REVISION LOG

REVISION:001

DATE: 10/09/2020

Portico 2020 LH

OPT. L-SHAPED SHOWER
SCALE: 1/8"=1'-0" ON 11x17, 1/4"=1'-0" ON 22x34

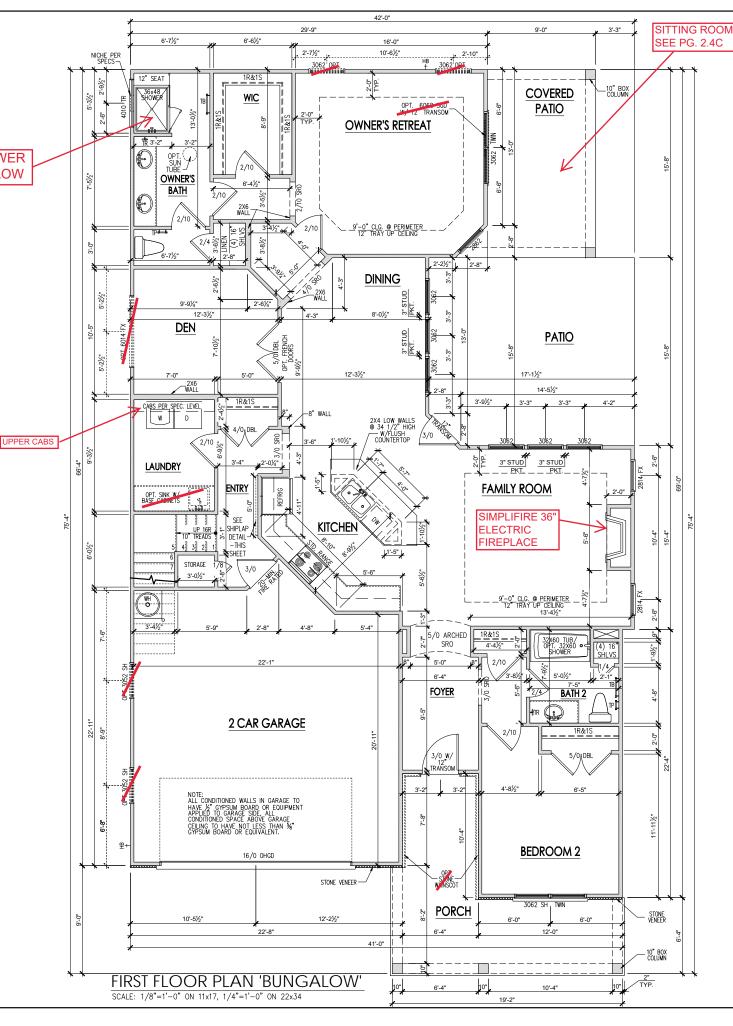
- ADD DELUXE KITCHEN OPTION
 RELOCATE NICHE IN L-SHAPED SHOWER IN OWNER'S BATH.
 CHANGE WAINCOL TURNING CORNER AT PORCH TO OPTIONAL.
 REMOVED TOWER INS IN BATH 3
 VERIFY OPT. WET BARS IS 81"
 MOVE WET BAT BUNDER COUNTER REFRIG. TO RIGHT SIDE OF SINK.
 REMOVE DIMENSIONS FROM HVAC PLATFORM.
